# SPRINGDALE Utah

## **Memorandum**

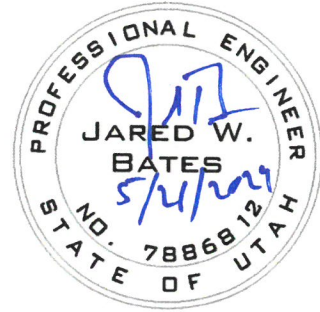
**REVIEW COMMENTS ON EROSION HAZARD ASSESSMENT  
ZION BOULEVARD EROSION PROTECTION  
SPRINGDALE, UTAH**

Below in red are the responses to the comments provided by the Town Engineer.

Review Comments
